Product Change Notification / SYST-13RHMM178

ERRATA - PIC18F06/16Q41 Silicon Errata and Data Sheet Clarifications Revision

PIC18F06/16Q41 Silicon Errata and Data Sheet Clarifications

1.5.1 UART TXDE Signal May go Low Before The STOP Bit Has Been Entirely Transmitted.

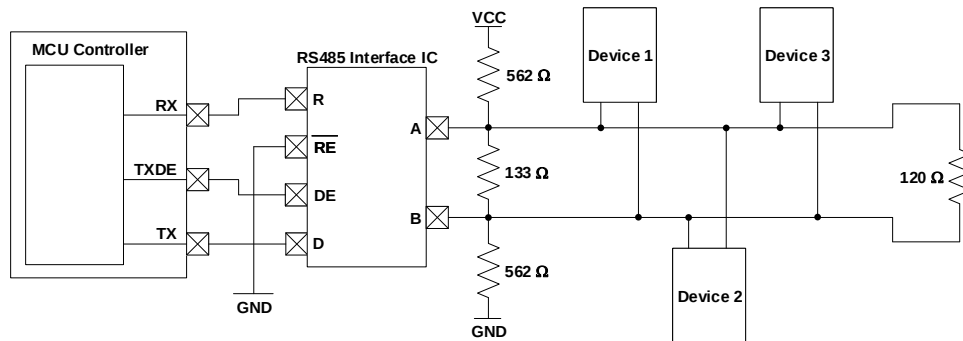
The UART Transmit Drive Enable (TXDE) signal could potentially transition into a low state before the UART STOP bit has been entirely transmitted due to the effects of parasitic capacitance on the TX line. In some applications, this could result in communication being prematurely terminated due to the TXDE bit going low before the STOP bit has had enough time to settle.

In order to ensure that the STOP bit settles into its final logic state before the TXDE signal transitions low, a biasing circuit can be implemented. A biasing circuit allows the TX line to either be driven high or low, rather than being left in a floating tri-state mode where prolonged rise or fall times could lead to communication being disrupted. This bias circuit should only be implemented on one end of the serial bus, and a termination resistor should be used on the other end. The figure below shows an example of a bias circuit that can be used to achieve this. Please note that the resistor values used in this circuit are recommendations, and that the actual resistor values required may vary based on the application.
